Intel® Desktop Board D865GBF Specification Update

Release Date: November 2004

Order Number: C41597-013

This document is an update to the specifications contained in the *Intel® Desktop Board D865GBF/D865GLC Technical Product Specification* (Order number C32634). It is intended for hardware system manufacturers and software developers of applications, operating systems, or tools. It will contain Specification Changes, Errata, Specification Clarifications, and Documentation Changes.

Figure 29a. Omnidirectional Airflow Heatsink

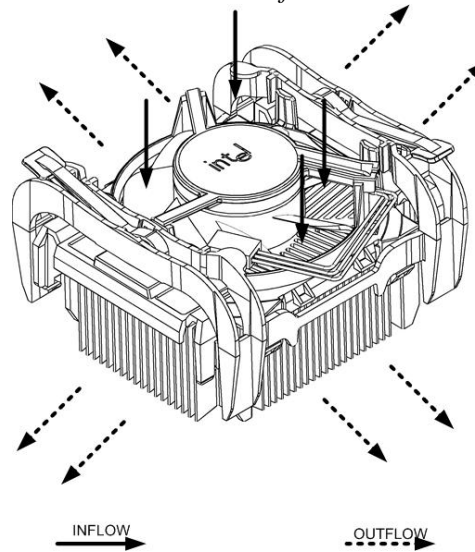
5. Change to Thermal Considerations, Section 2.12

Section 2.12, Thermal Considerations will change in its entirety as follows:

The use of an Intel Pentium 4 processor with 1 MB of L2 cache on this Intel desktop board requires the following:

- *A chassis with a maximum internal ambient temperature of 38 Degrees Celsius*
- *A processor heatsink that provides omnidirectional airflow so that air is drawn across the processor voltage regulator area (item A in Figure 30). Figure 29a illustrates an omnidirectional airflow heatsink.*

Figure 30. Localized High Temperature Zones

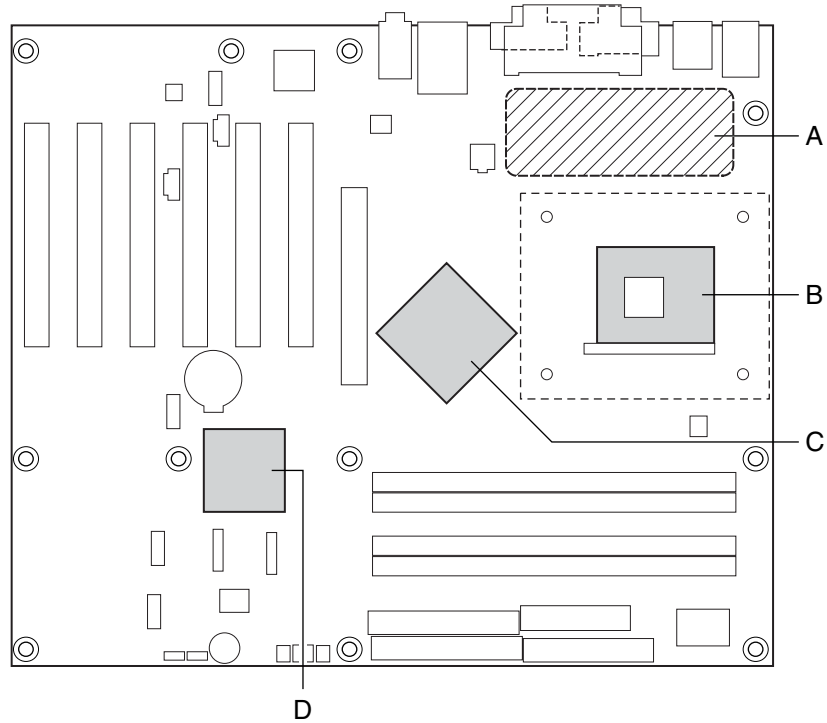
Ensure that proper airflow is maintained in the processor voltage regulator circuit. Failure to do so may result in damage to the voltage regulator circuit. The processor voltage regulator area (item A in Figure 30) can reach a temperature of up to 85 °C in an open chassis.

Figure 30 shows the locations of the localized high temperature zones.
